**STAFF REPORT**  
**KETCHUM PLANNING AND ZONING COMMISSION**  
**June 14, 2022 MEETING**

**PROJECT:** McDermott Residence Mountain Overlay Design Review

**FILE NUMBER:** P22-002

**REQUEST:** Mountain Overlay Design Review

**2 Southwest Courtyard Elevation**  
SCALE: 1/4" = 1'-0"

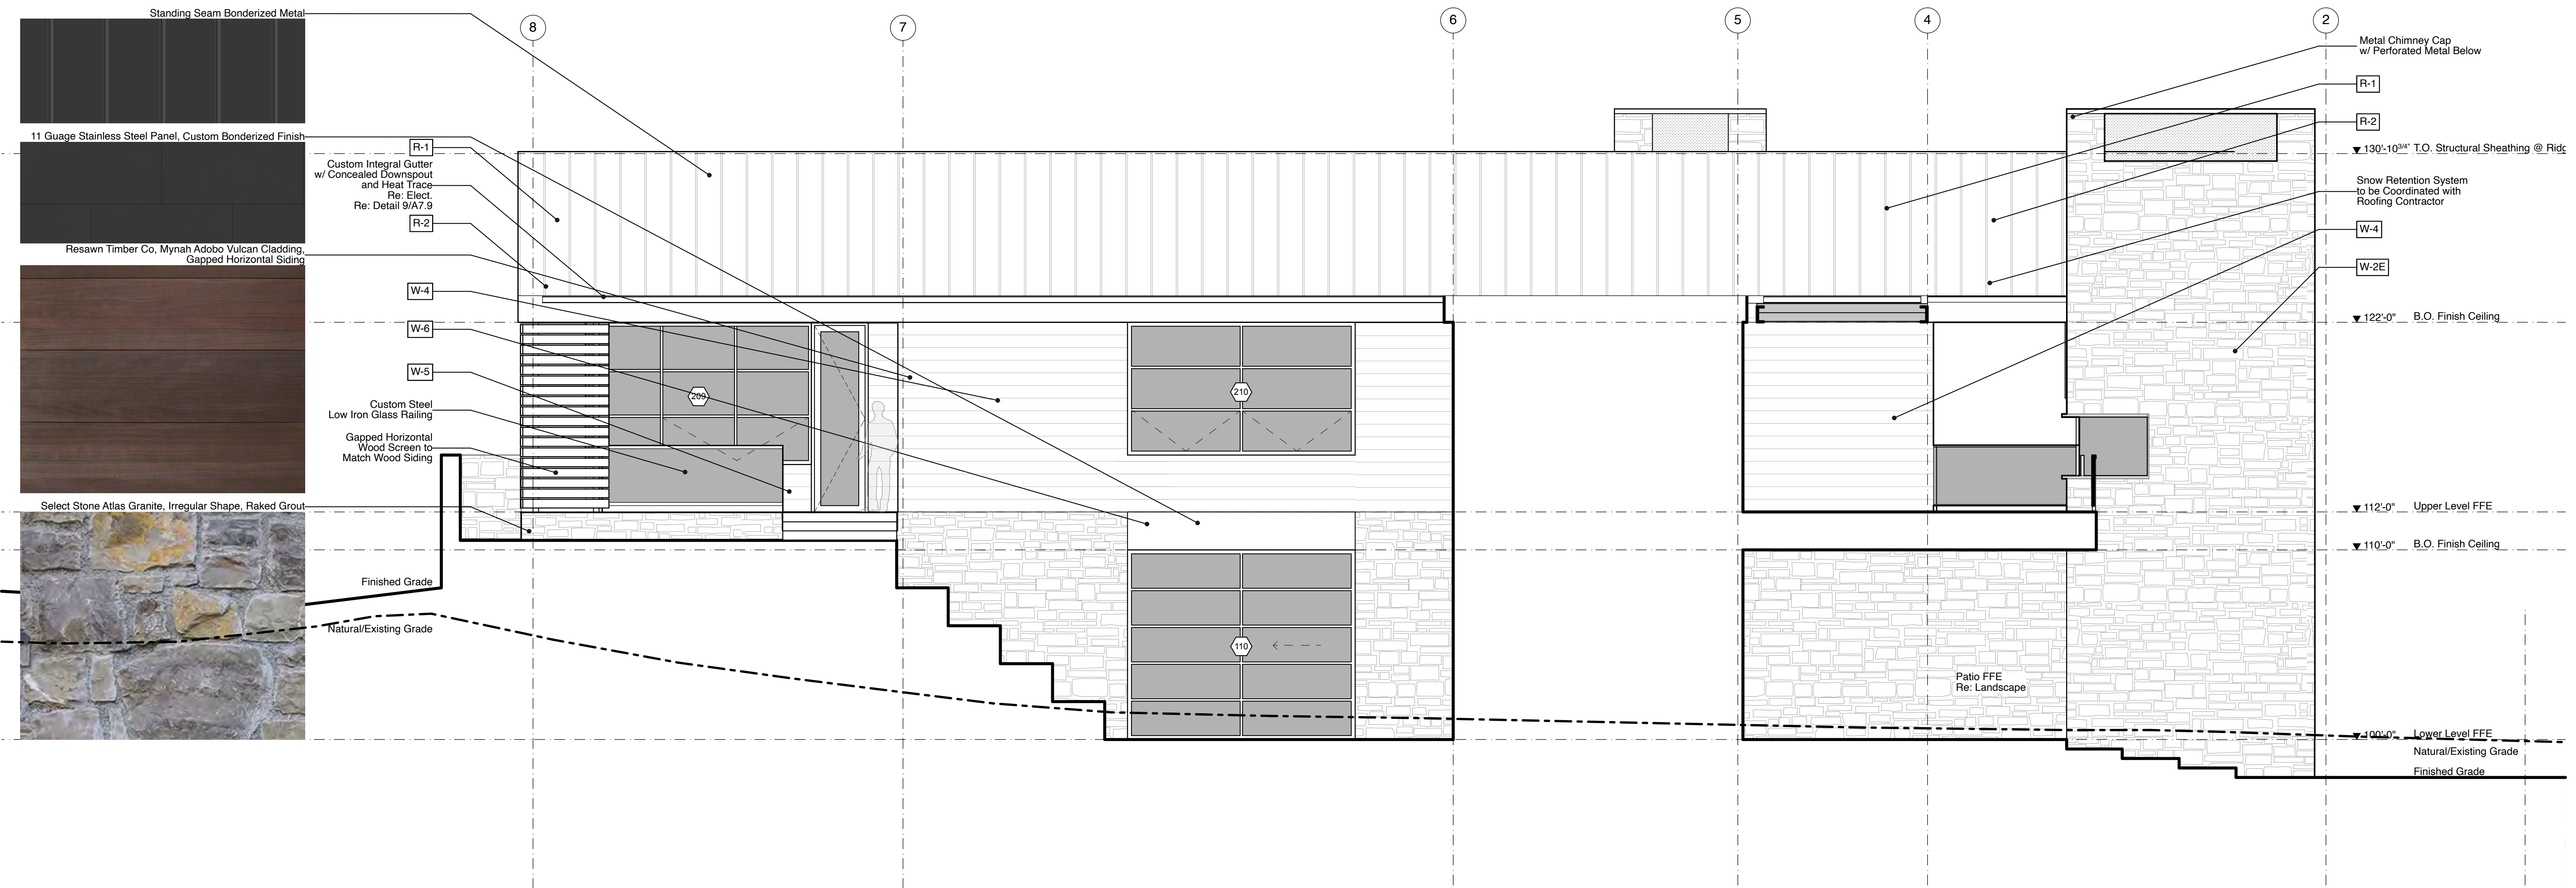
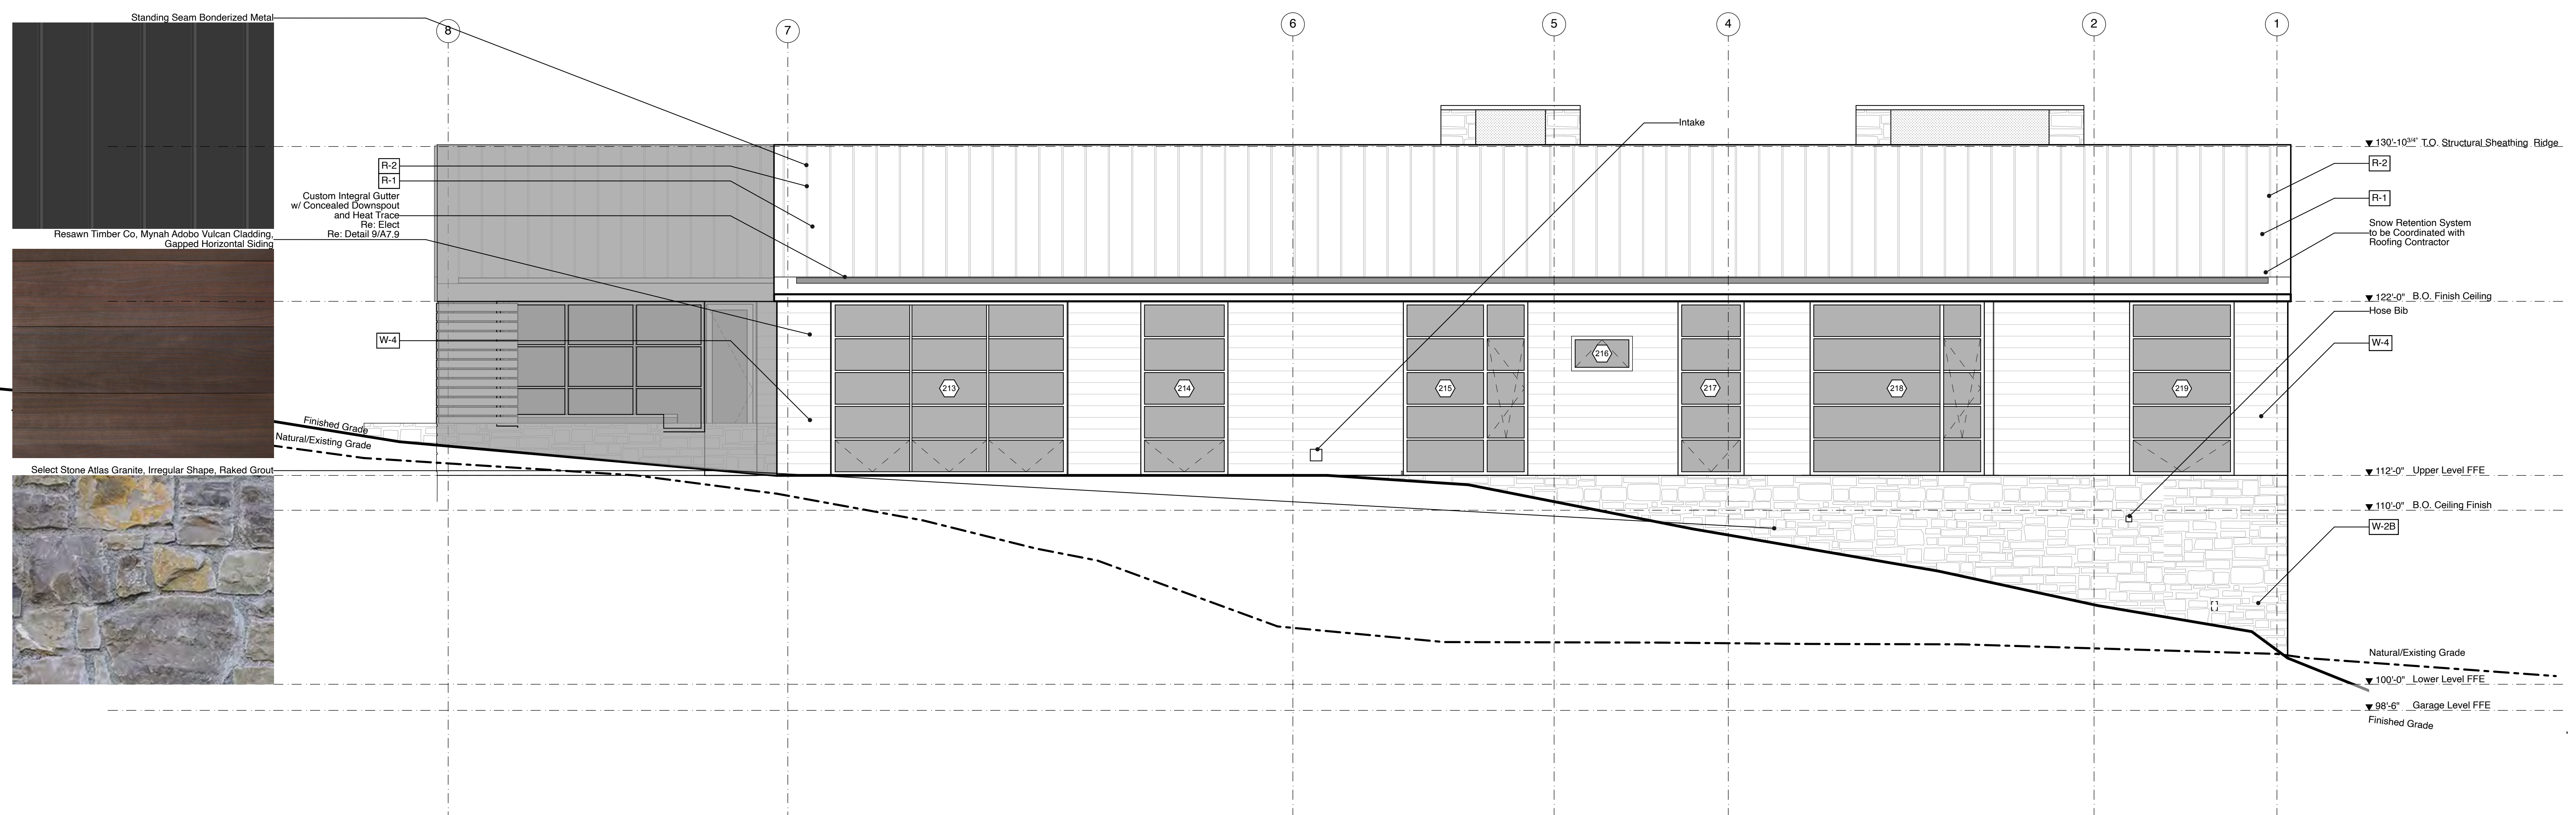
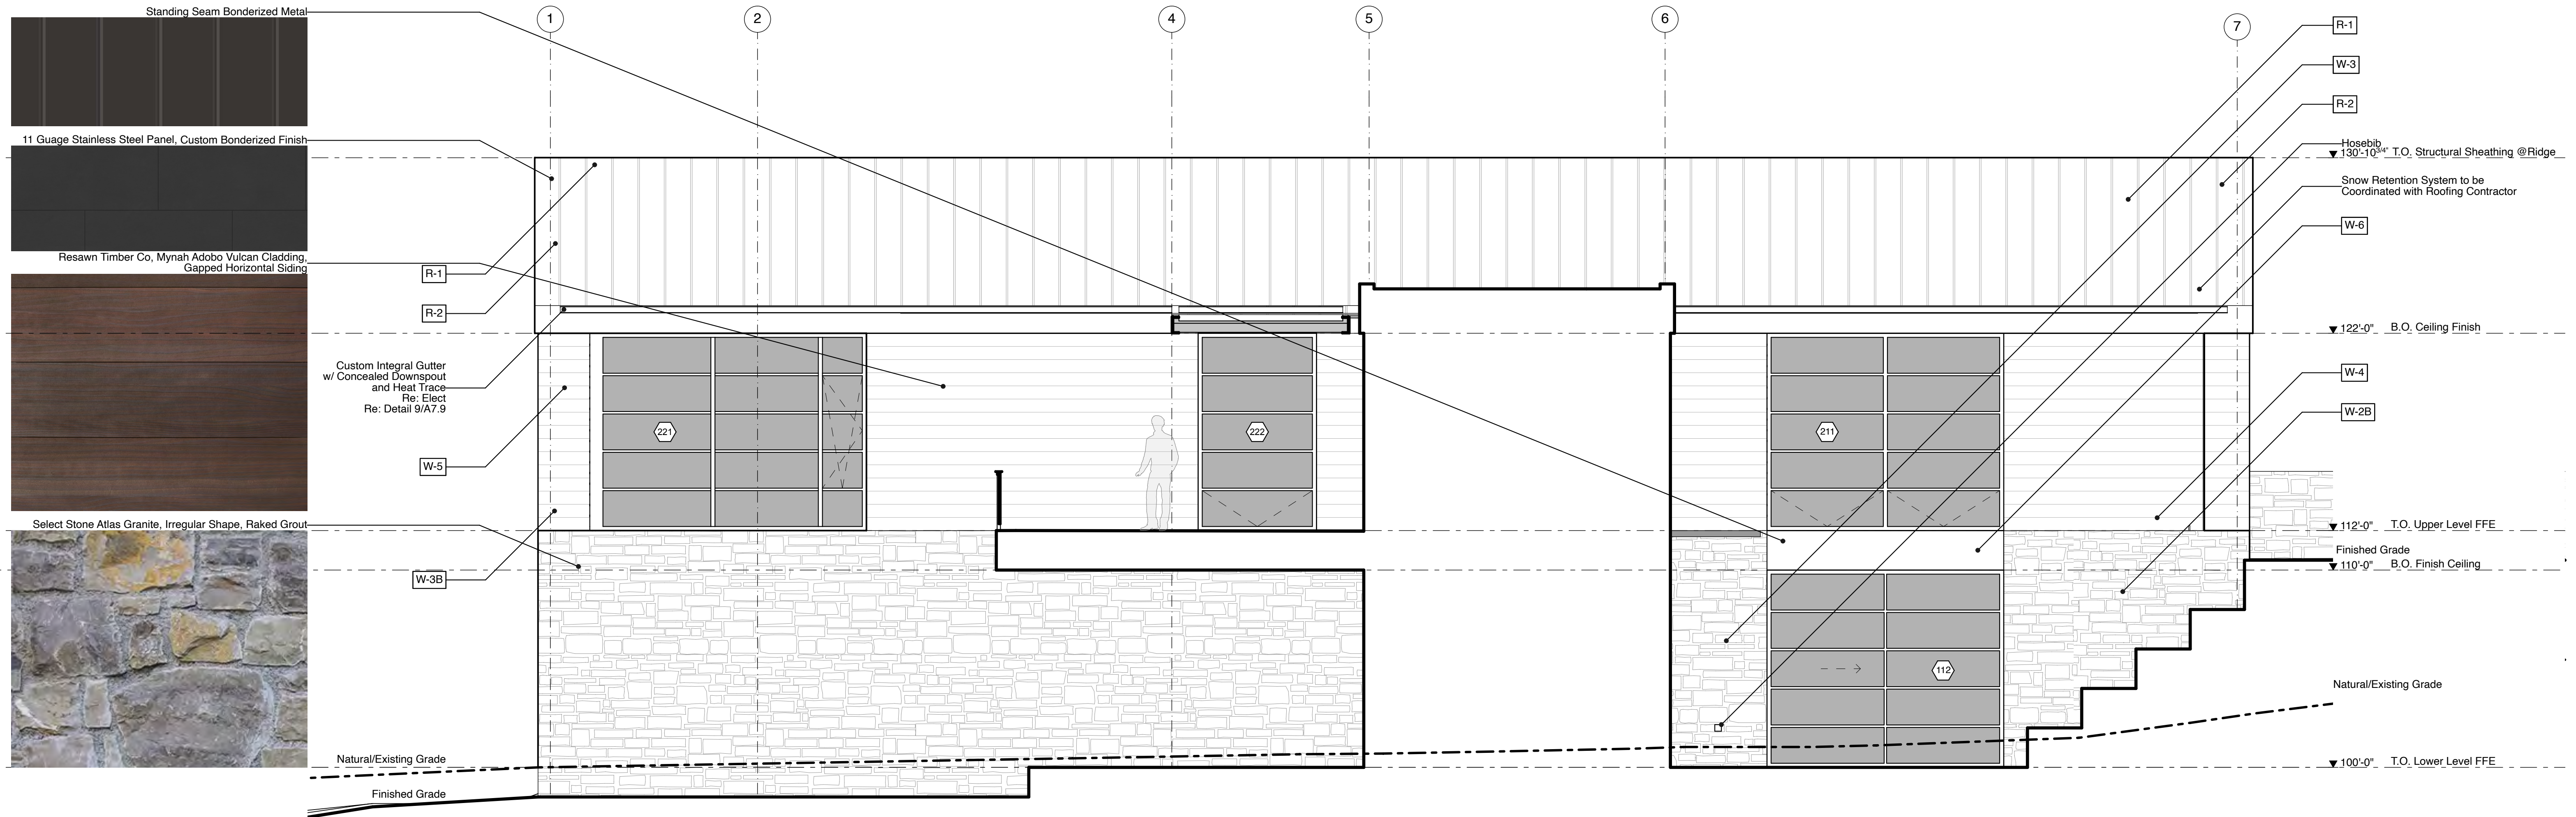
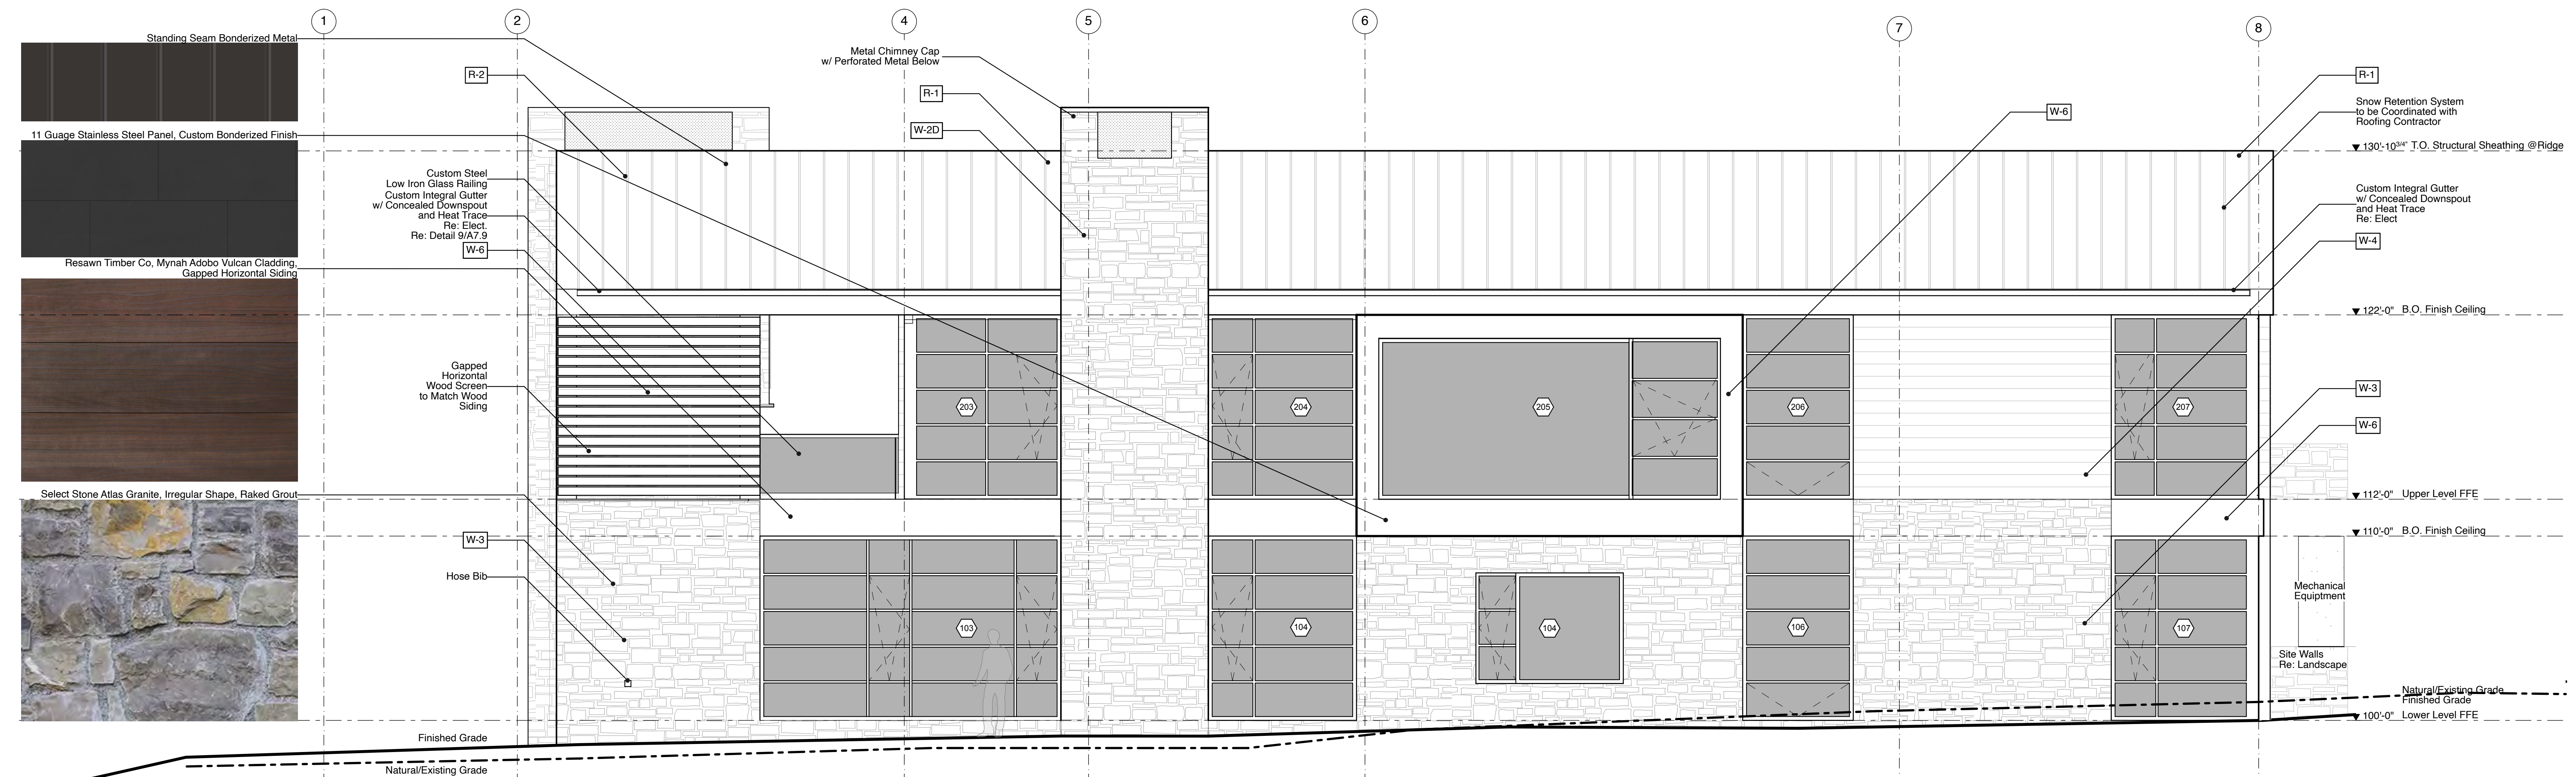
<i>Staff Comments</i>	Building elevations are included on Sheets A3.1, A3.2, A3.3 of the Design Review Submittal. Chimneys, bump outs, balconies and undulation help to provide visual interest. The use of windows on the Walnut Ave & 6 <sup>th</sup> St frontages assists in breaking up the buildings façade.
<input checked="" type="checkbox"/>	<input type="checkbox"/>	<input type="checkbox"/>	17.96.060(F)(3)	<b>There shall be continuity of materials, colors and signing within the project.</b>
			<i>Staff Comments</i>	The proposed materials and color palette enhance the mountain modern design of the single-family residence. The natural materials and colors complement the surrounding landscape.
<input checked="" type="checkbox"/>	<input type="checkbox"/>	<input type="checkbox"/>	17.96.060(F)(4)	<b>Accessory structures, fences, walls and landscape features within the project shall match or complement the principal building.</b>
